**From:** Kynan Simmons  
**Sent:** 02 January 2019 18:07  
**To:** Megan O'Mara  
**Subject:** Re: Church of St Stephen, Fylingdales

I write to you regarding Listed Building application NYM/2018/0797/LB.

REVISION	DATE	DRAWN	CHECKED	DESCRIPTION	CLIENT	SCALE
				Do not scale from drawing. All dimensions to be checked onsite. Report all discrepancies.	The Churches Conservation Trust	as shown at A3
					PROJECT	DATE
					OLD ST STEPHEN, FYLINGDALES	January 2019
					Cupola	
					DRAWING TITLE	
					simmonsherriff LLP is a Limited Liability Partnership registered in England and Wales. Registered number: OC354236. Registered Office: 30-38 Dock Street Leeds LS10 1JF.	
					JOB NUMBER	DRAWING NO.
						FSS000 / 21

REVISION	DATE	DRAWN	CHECKED	DESCRIPTION
Do not scale from drawing. All dimensions to be checked onsite. Report all discrepancies.				
				CLIENT
				SCALE
				no scale at A4
			PROJECT	DATE
			DRAWN	October 2018
			KS	
			CHECKED	
<b>ST STEPHEN, FYLINGDALES</b>				
<b>NAVE</b>				
<b>NORTH SIDE RAINWATER DISPOSAL</b>				
DRAWING TITLE				simmonsherriff LLP is a Limited Liability Partnership registered in England and Wales. Registered number: OC354236. Registered Office: 30-38

SECTION BB 1:20

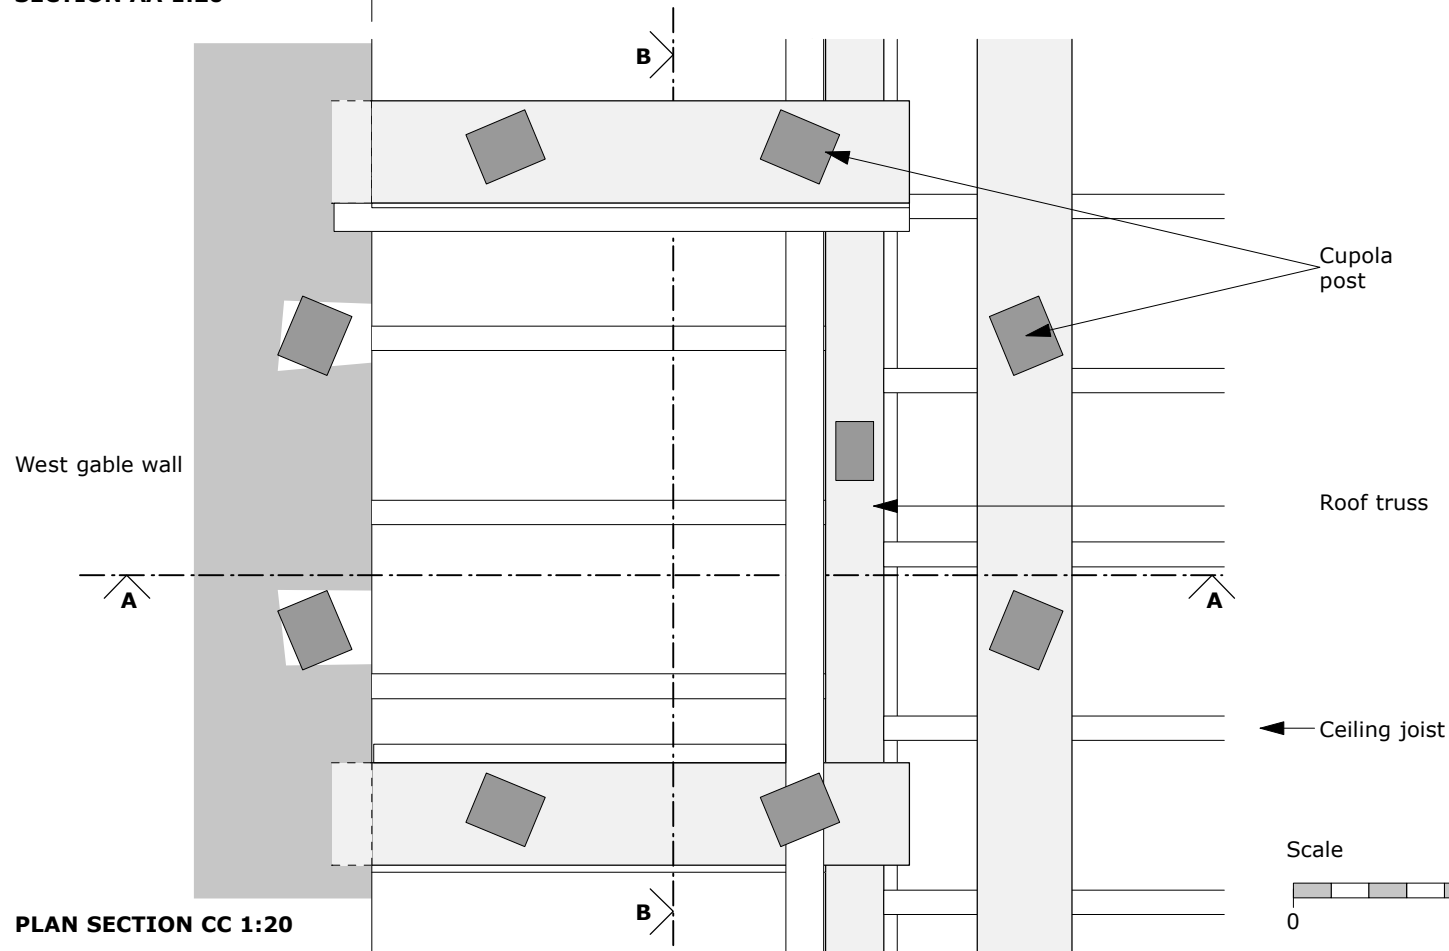
It would appear that the plans submitted for the above application do not include the proposed plans for Section BB of the development. The proposed design is not included in the Design and Access statement and the plans only show the existing. I would ask that these are submitted to the Authority at your earliest convenience.

Further to our telephone conversation earlier today, please find attached a copy of drawing FSS000/021 showing proposed strengthening and repairs (including Section BB) for the Cupola. As noted, this drawing is to be read in conjunction with the Structural Engineer's proposals included in The Design and Access Statement, Appendix A. I trust this provides the information you need, please do let me know if you require anything more.
